ADDENDUM 01

Addendum to the drawings and specifications for:
Kendall County – Emergency Medical Services Station No. 3

EMERGENCY MEDICAL SERVICES STATION NO.3

10.06.23

1 PARTIAL FLOOR PLAN
1/4" = 1'-0" NEW CONSTRUCTION

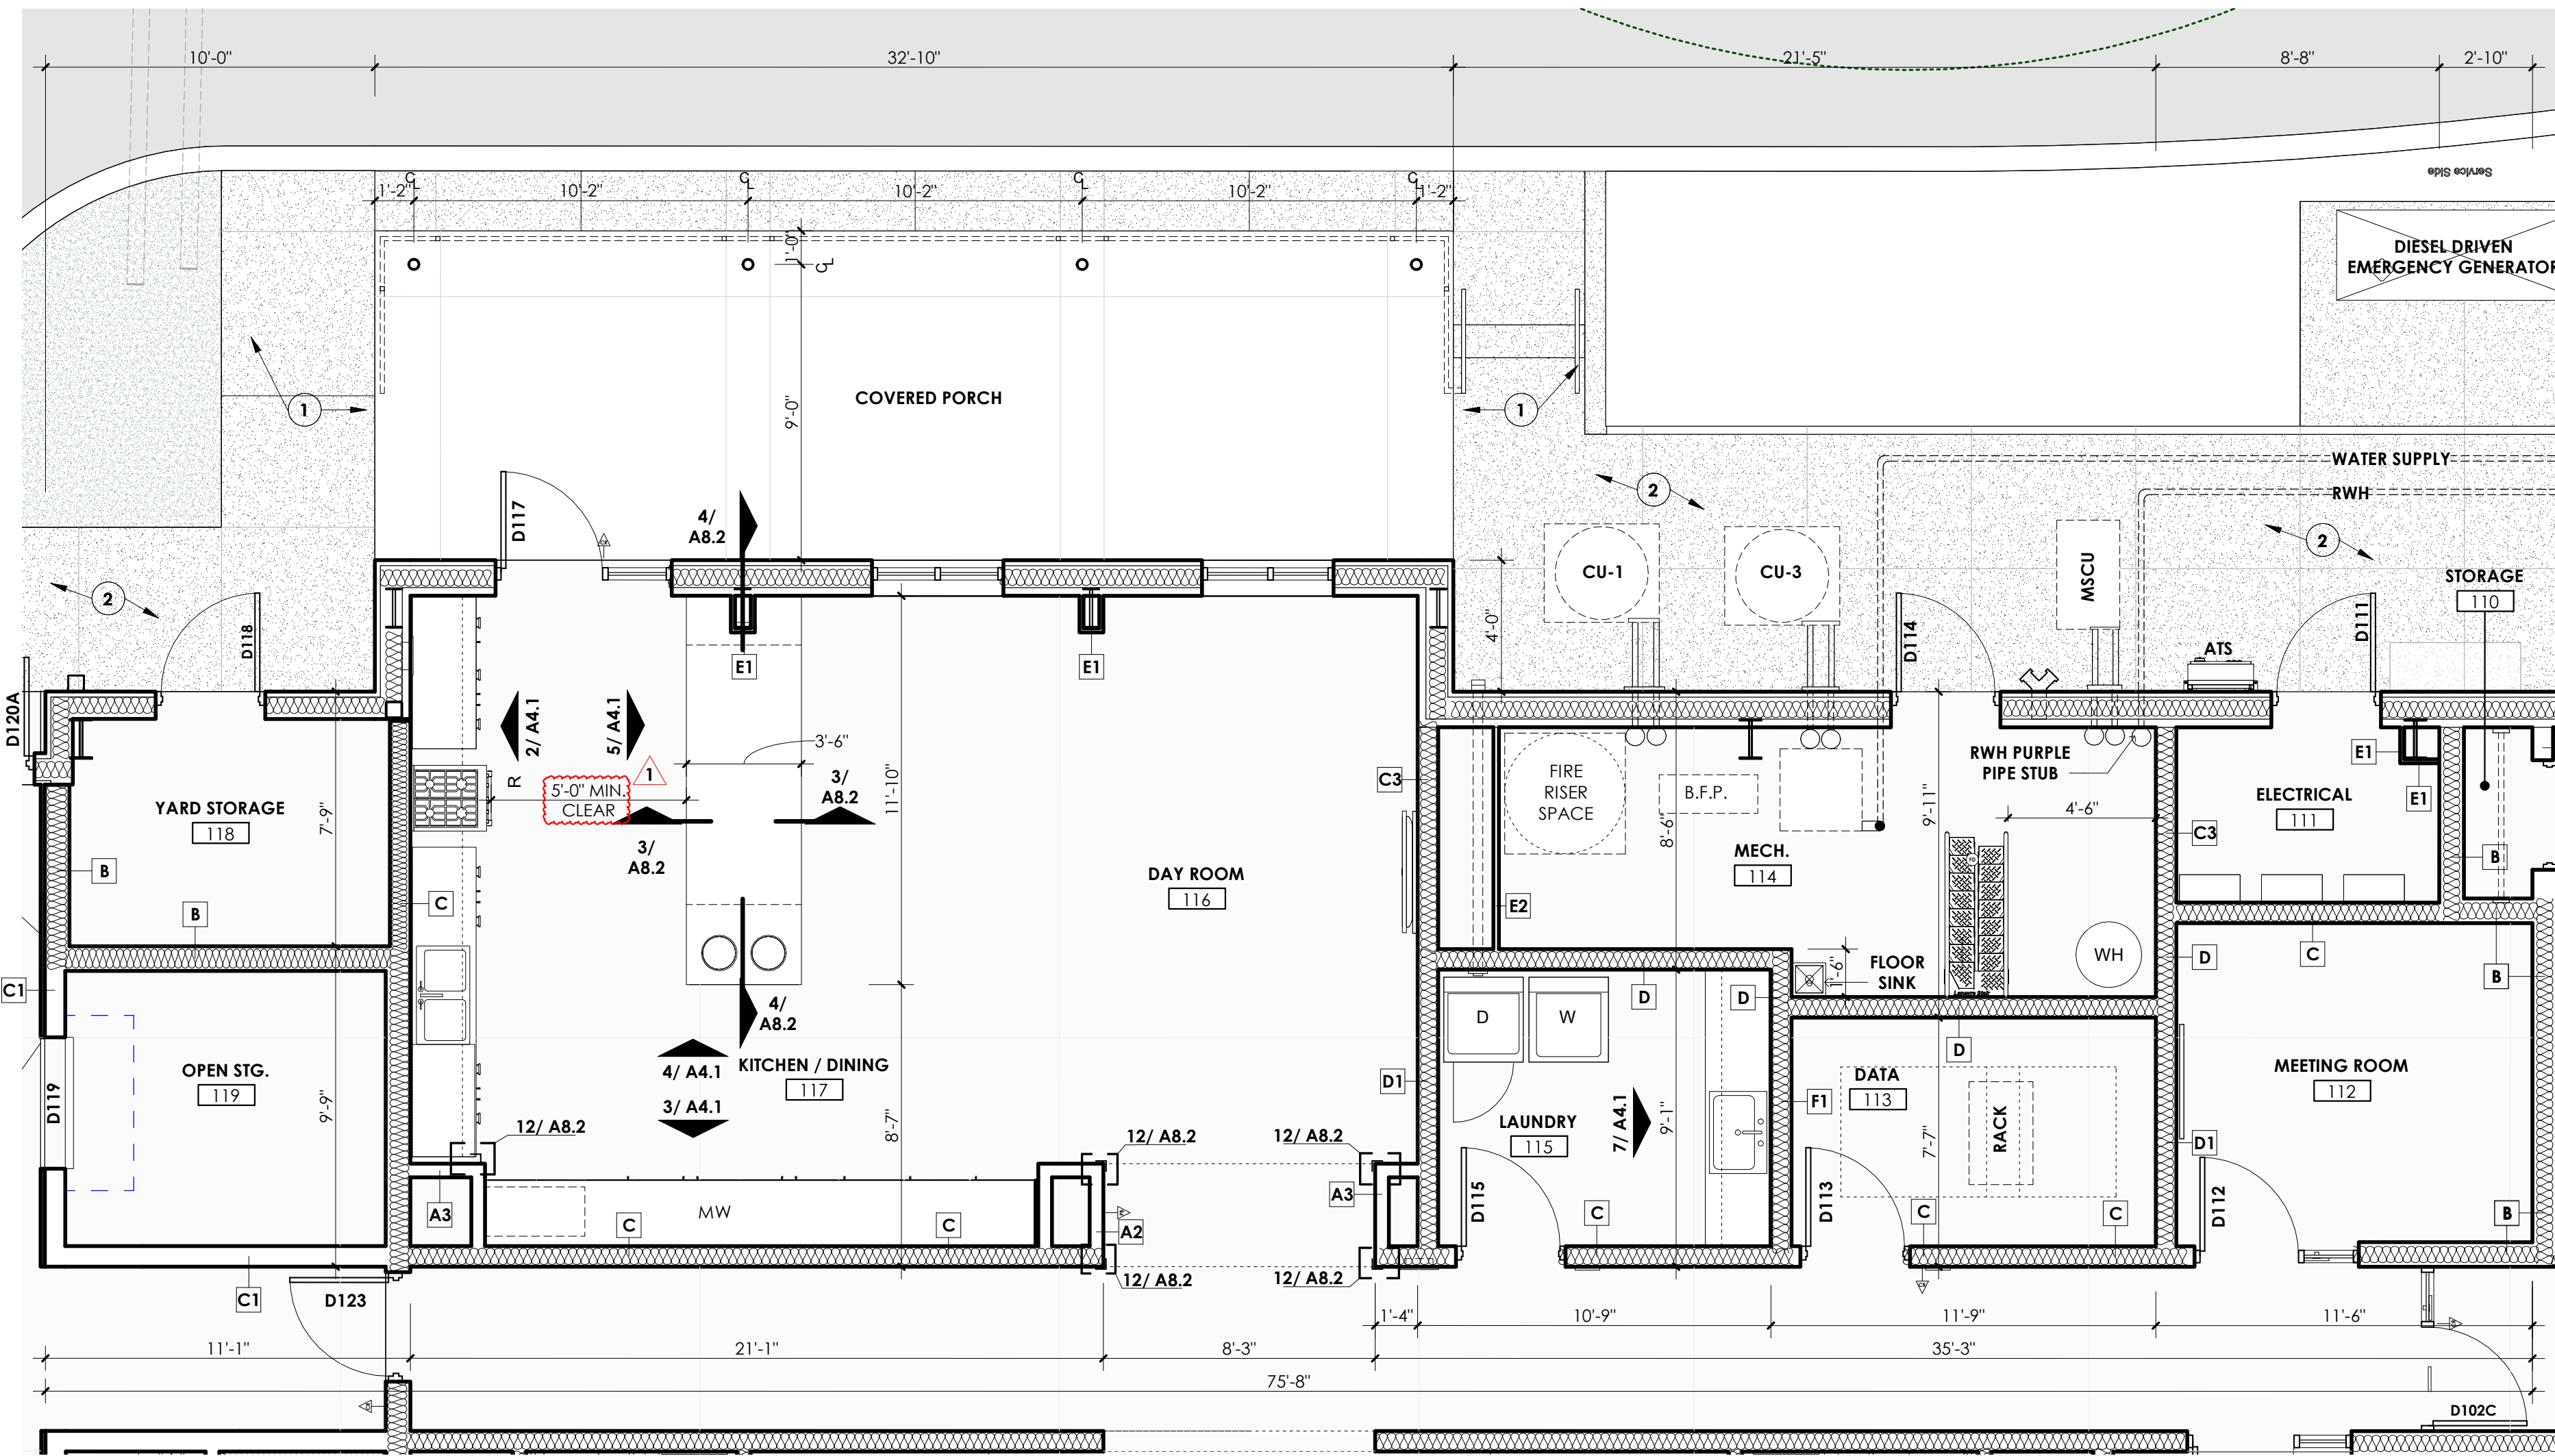
Refer to revised sheet A4.1 to include a clarification dimension added to partial plan 1.

1 ROOF PLAN
1/8" = 1'-0" NEW CONSTRUCTION

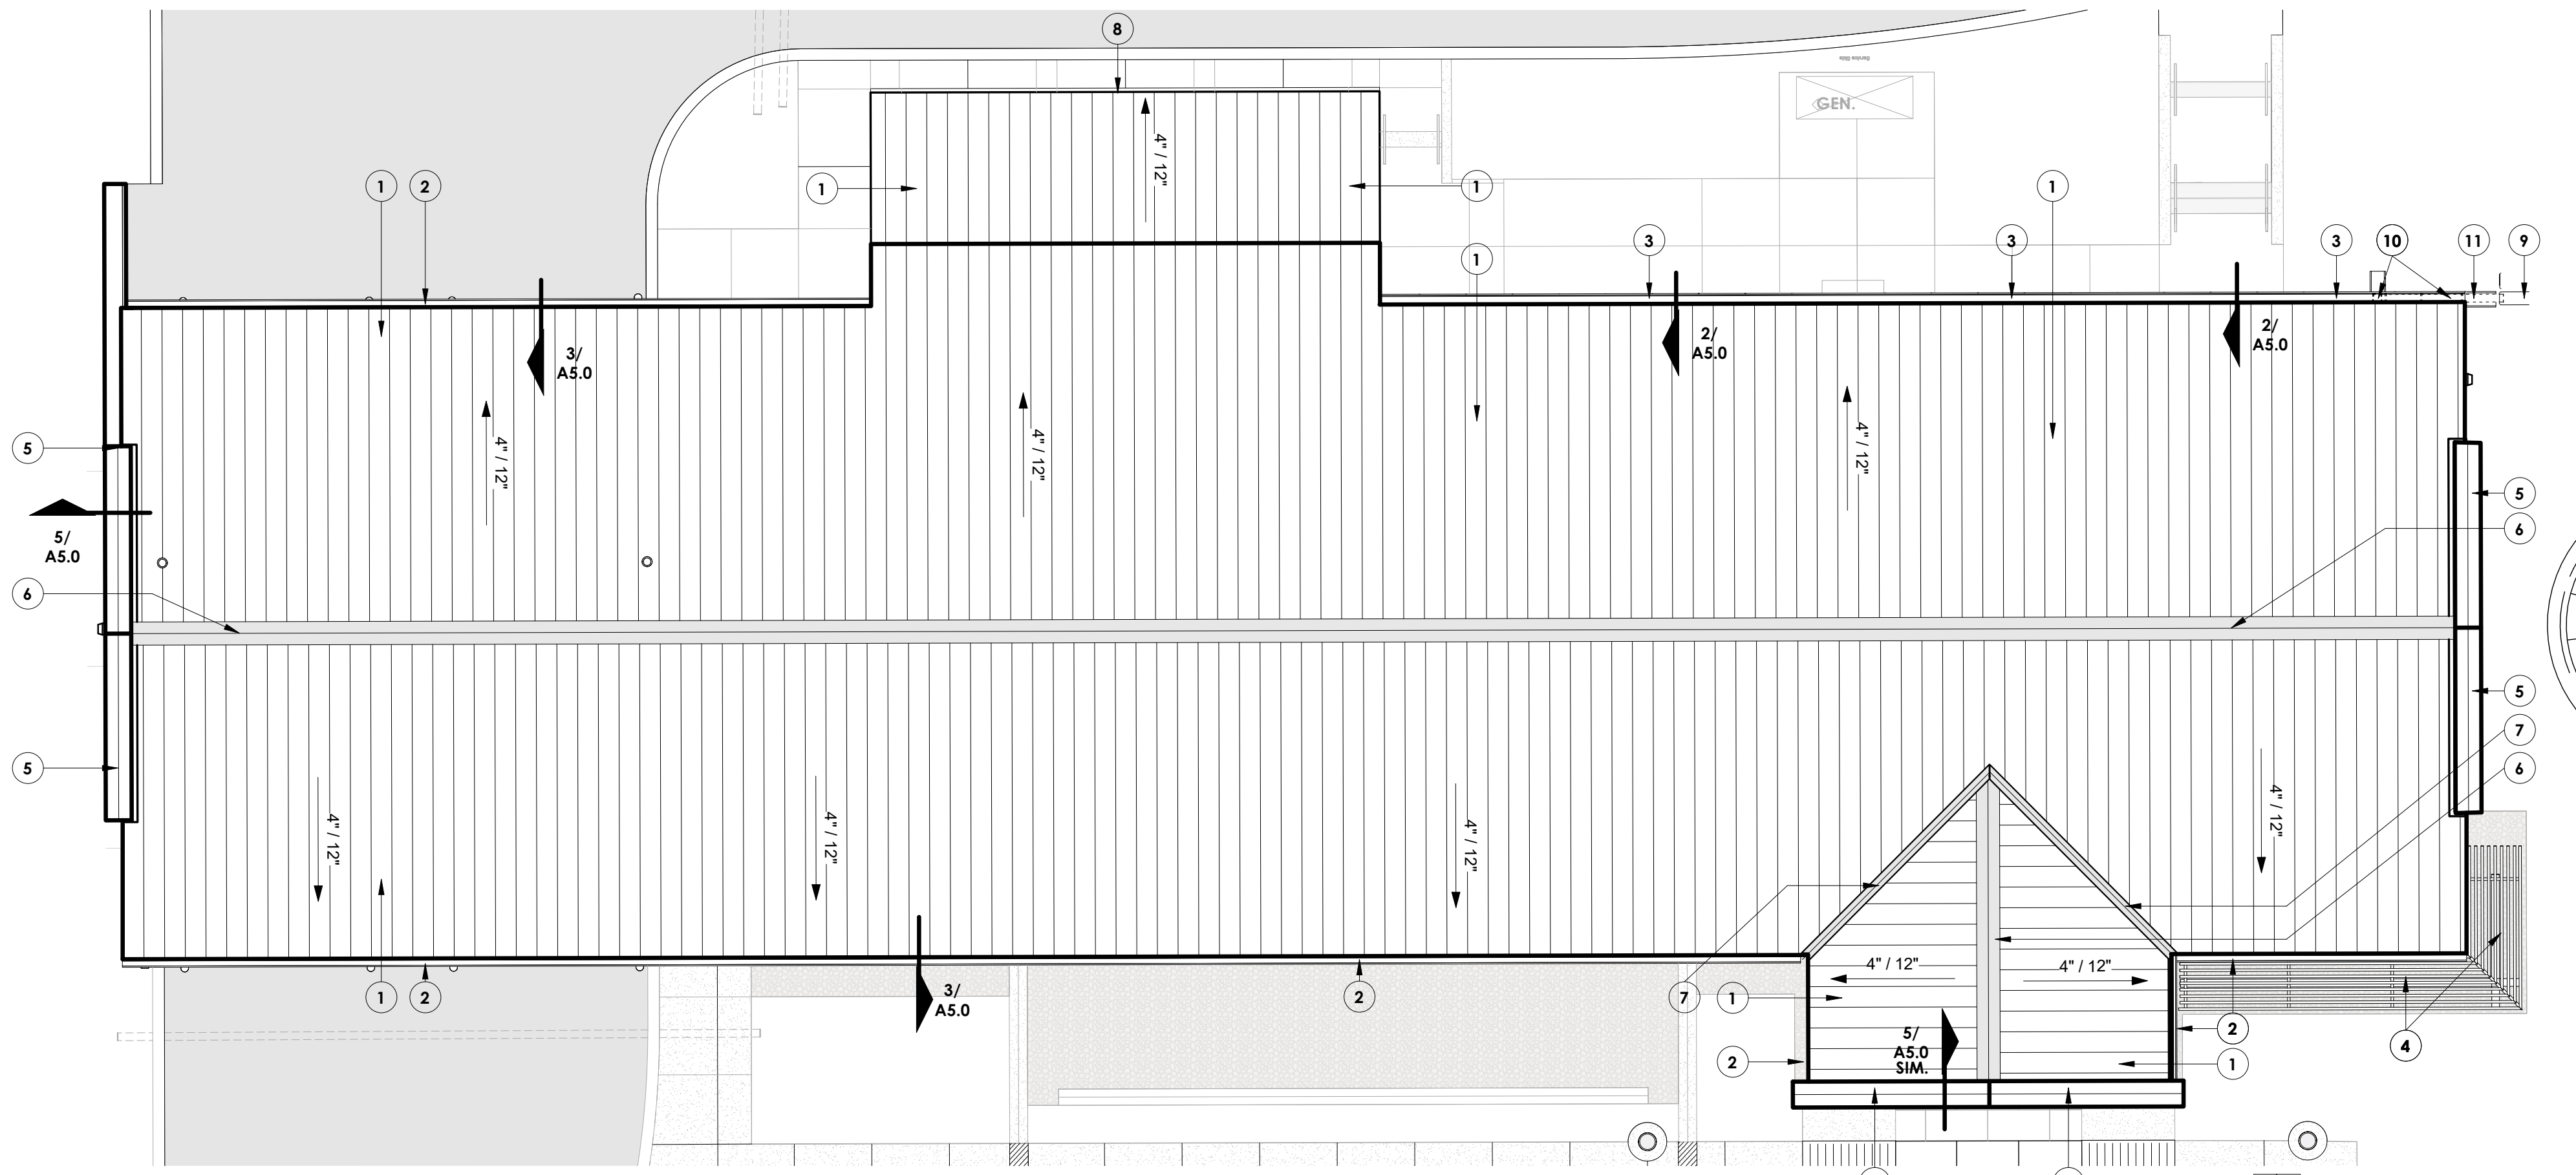
4. **Question :** Architectural details show roof underlayment, but there is no roof deck called out. Please confirm that underlayment is not required or clarify if roof decking is required.?

Response to Question 4: *No Sheathing Required, provide P.E.M.B. typical roof assemblies. Refer to revised details on sheet A5.0 as clarification of design intent.*

A5.0

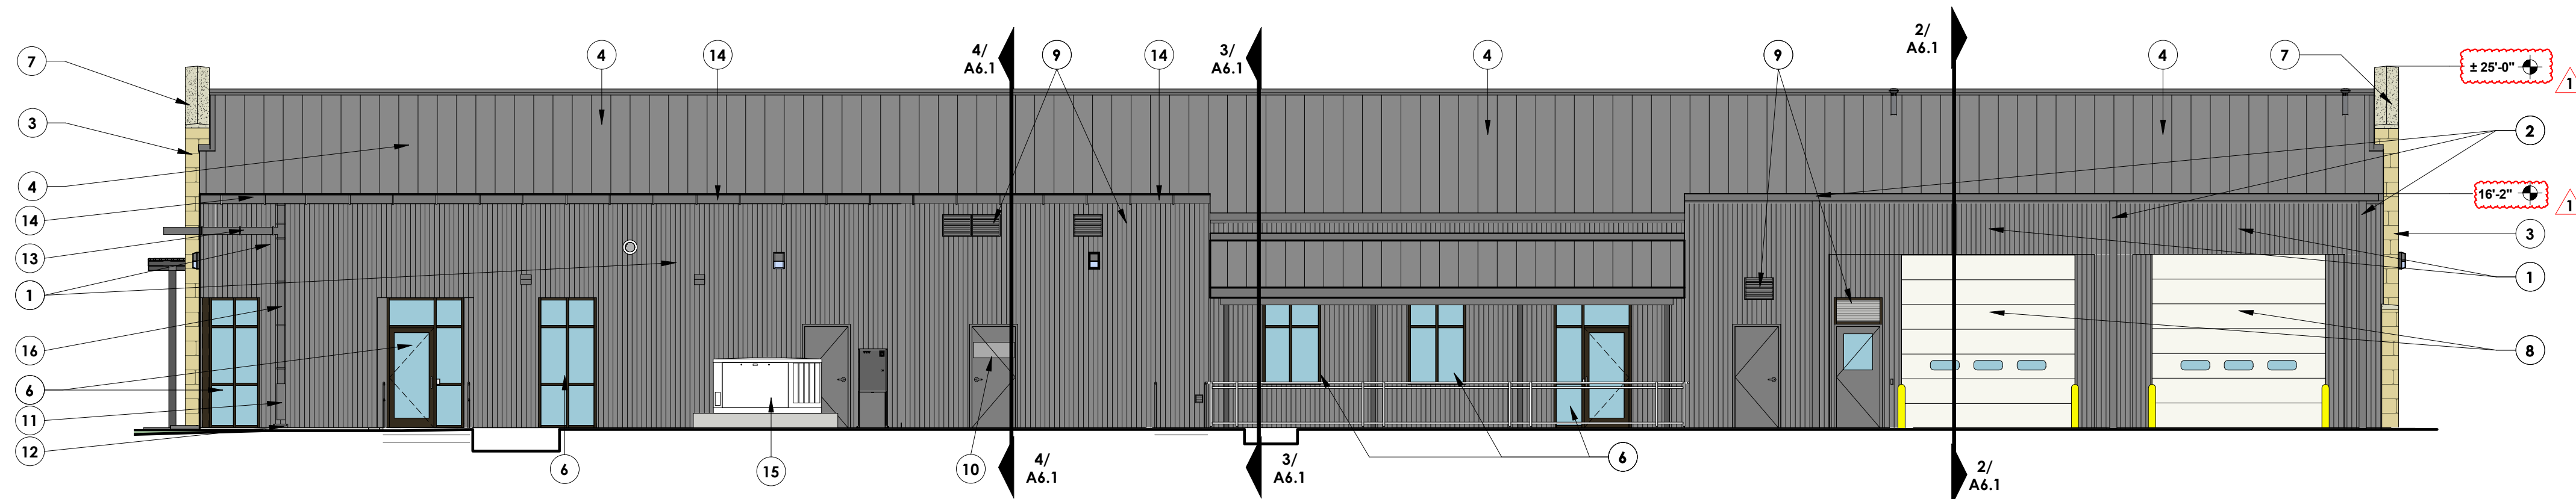
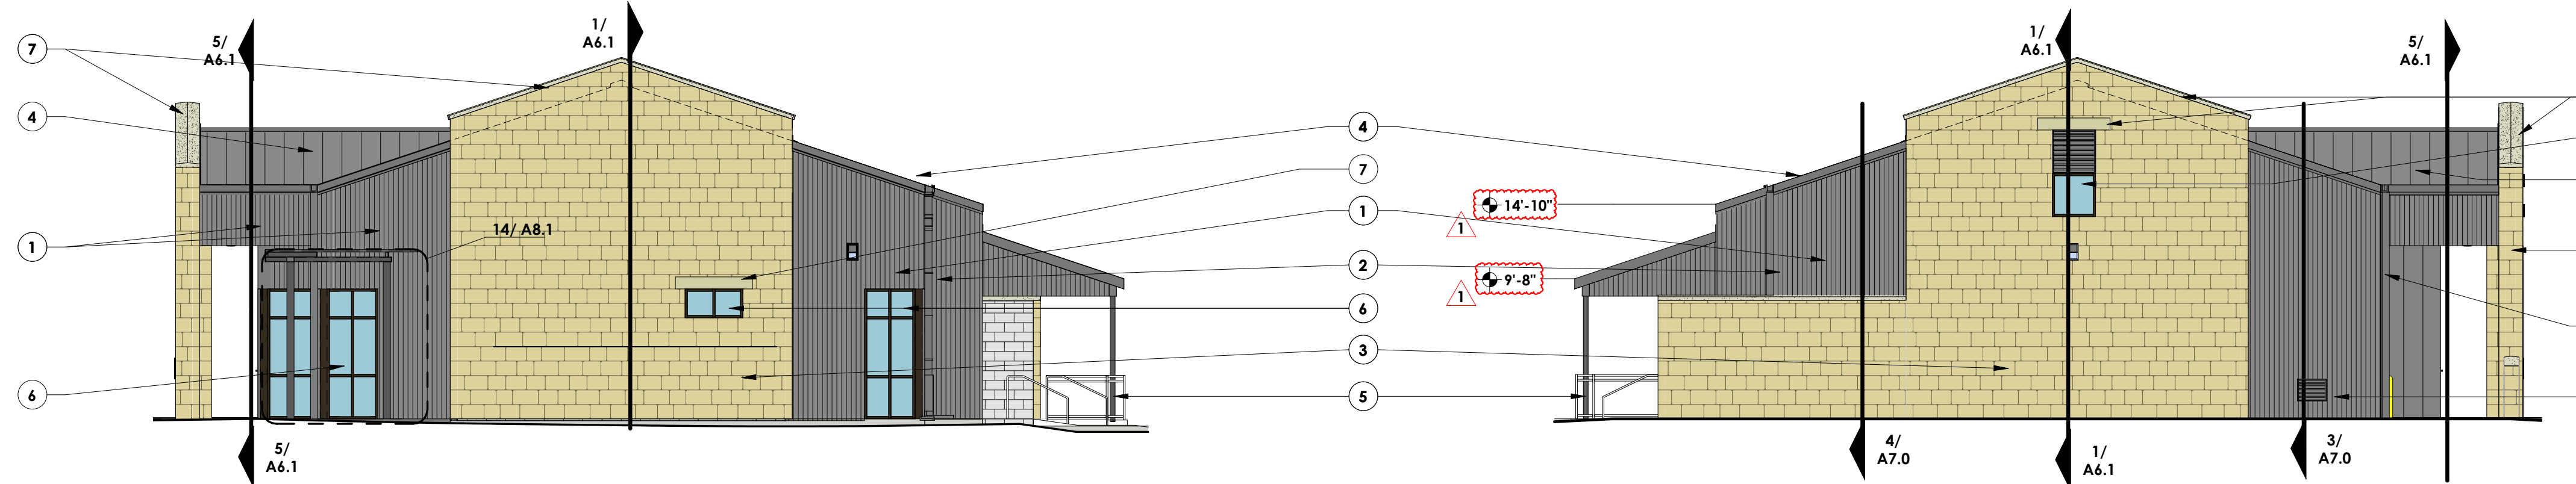
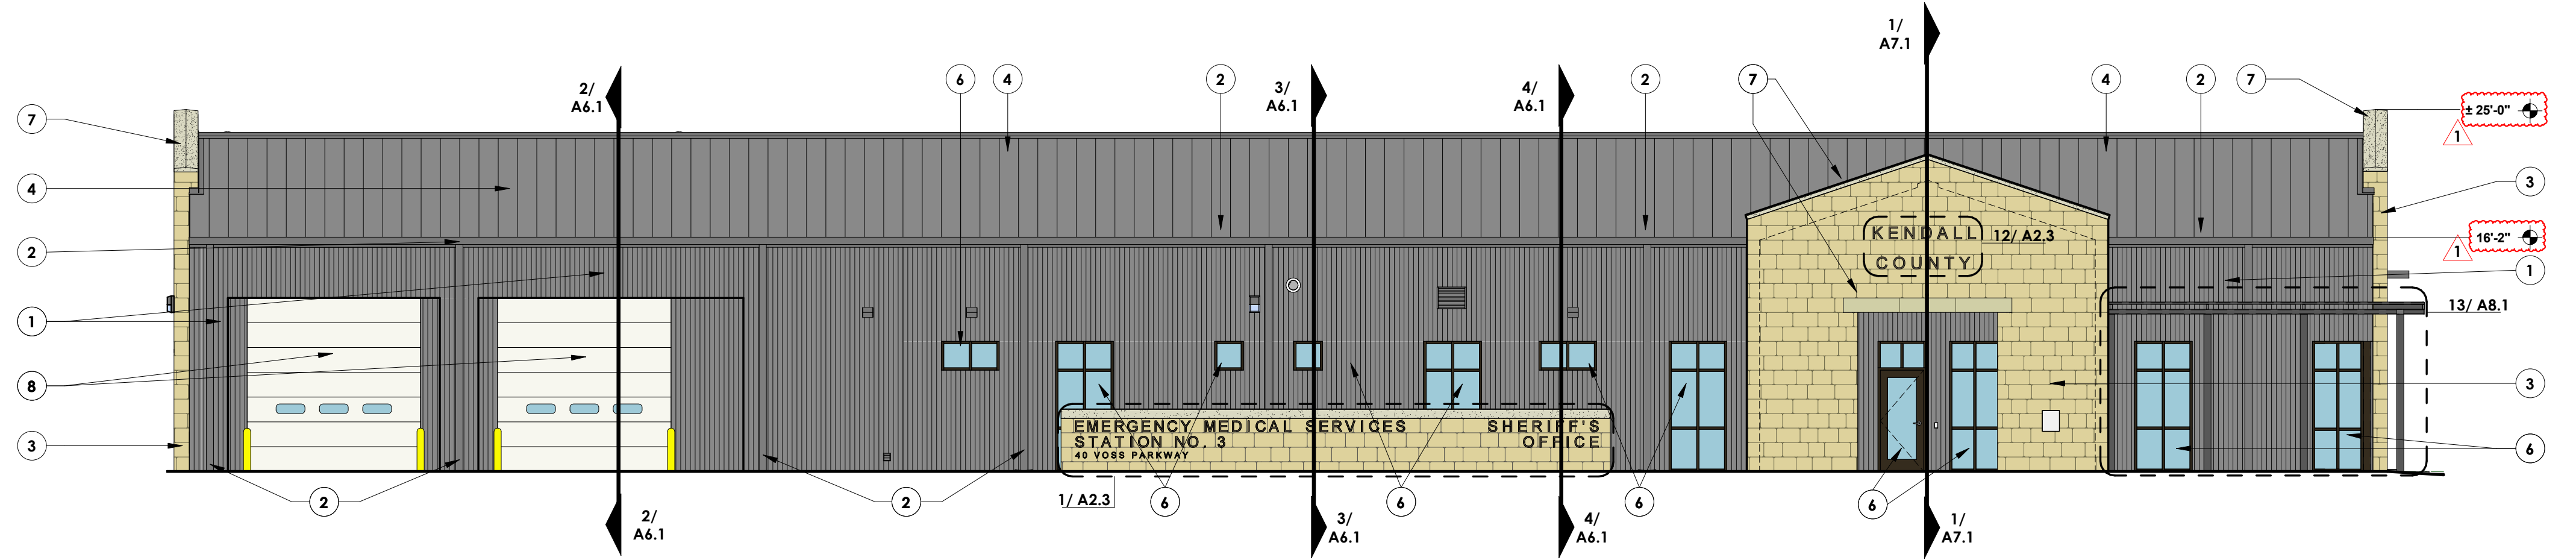
27. Question : Eave height on Roll up Overhead doors. We see no height elevations on building sections or plan elevation sheets?

Response to Question 27 : Building Eave Heights added to sheet A6.0, refer to Sheet A1.2 for nominal exterior O.H. door sizes.
